# 787-8

## Flight Crew Operations Manual Bulletins

### Air India Limited

Bulletin Package Revision: 8F  
Bulletin Package Date: January 23, 2013

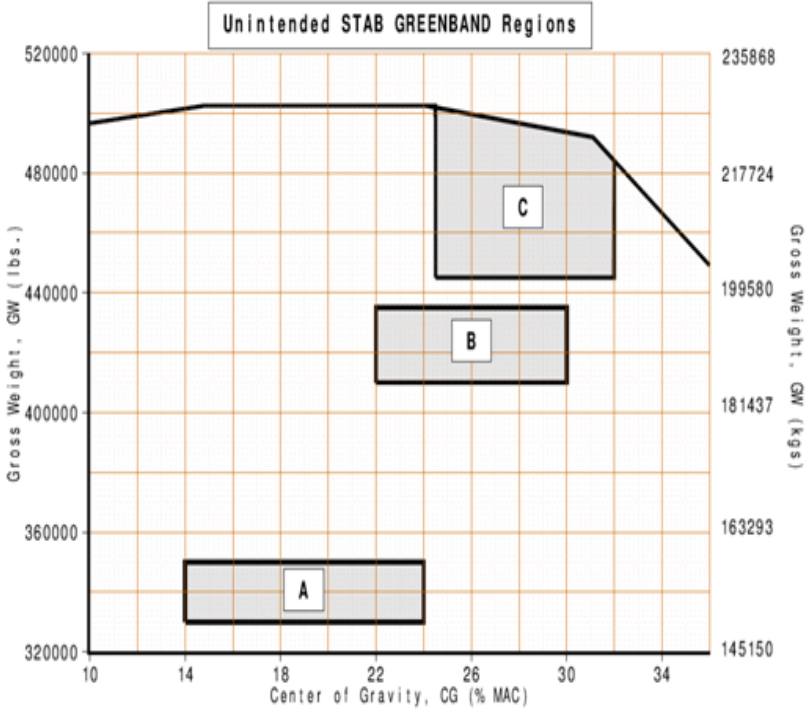
An anomaly in the stabilizer greenband monitor and alert system may result in an erroneous STAB GREENBAND message. In some regions of the GW and CG envelope, the greenband validation check has a very small margin against unintended or nuisance alerts. When the airplane is loaded in these regions the greenband monitor and alert system calculation may disagree with the greenband computed from FMC entries resulting in an erroneous STAB GREENBAND message.

If a STAB GREENBAND message shows after loading is complete, crews should accomplish the STAB GREENBAND non-normal checklist.

When verifying airplane loading an additional check may be accomplished to verify that the STAB GREENBAND message is a nuisance. Use the chart below to identify regions of the GW and CG envelope most susceptible to this nuisance message. If the airplane GW and CG are in region A, B, or C, the flight crew may confirm the nuisance by temporarily entering a CG value 3% MAC forward (lower value) than the value on the load manifest. This temporary entry causes the greenband trim range to be recalculated. If the message blanks after approximately 5 seconds, the nuisance condition is verified. (If the message stays shown after 5 seconds, the nuisance condition is NOT verified.) The flight crew must then re-enter the correct CG value from the load manifest and check that the stabilizer is set to the correct position. The message is likely to show again approximately 30 seconds after the correct CG is re-entered. If the STABILIZER GREENBAND checklist is displayed again, it should be overridden.

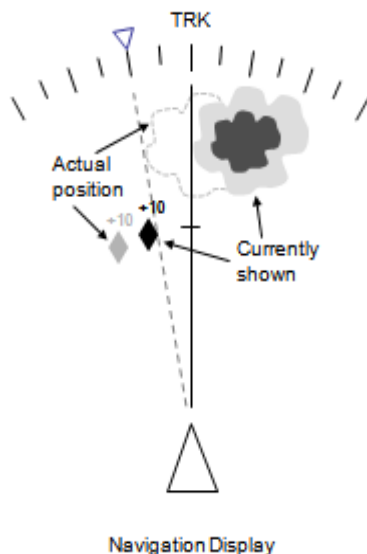
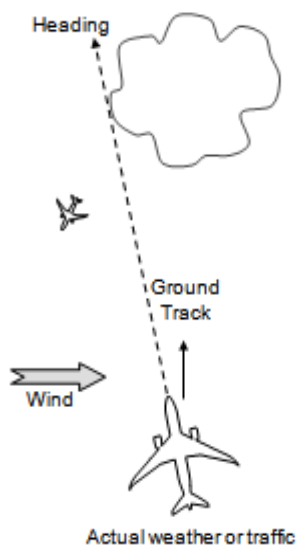
A software anomaly has resulted in TCAS, PWS, and WXR data showing with an incorrect heading-up orientation on the ND map and mini-map (track-up displays). TCAS, PWS, and WXR data that should show relative to the aircraft heading are actually shown relative to the track line. As a result, TCAS, PWS, and WXR data are rotated in the downwind direction with the angular error (angle of rotation) equal to the drift angle.

TCAS TA and RA messages and annunciations are correct and should be followed. When visually scanning for TCAS traffic that is shown relative to the track line the crew should scan in the same direction relative to the aircraft nose.

### Predictive Windshear

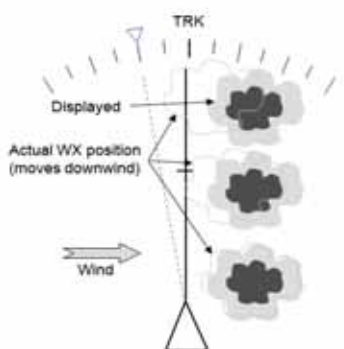
PWS messages and annunciations are correct and should be followed.

ND Radar Target Displayed  
Downwind of Track

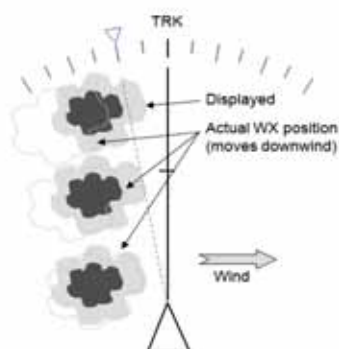
Weather shown downwind of the track line will continue to move away from the track line. For weather shown upwind of the track line, the aircraft track will be further from the weather than shown. While the angular error stays constant (equal to the drift angle), the magnitude of the cross track error will decrease as the range to the weather decreases and will be zero when the aircraft is abeam the weather target.

- Crews should plan the aircraft track to clear weather with the appropriate margins.
- In Visual Meteorological Conditions (VMC), the crew should avoid hazardous weather visually.
- In Instrument Meteorological Conditions (IMC), the crew should assess the weather radar display as the airplane approaches potentially hazardous weather and adjust the aircraft track to clear the weather as shown with the appropriate margins.
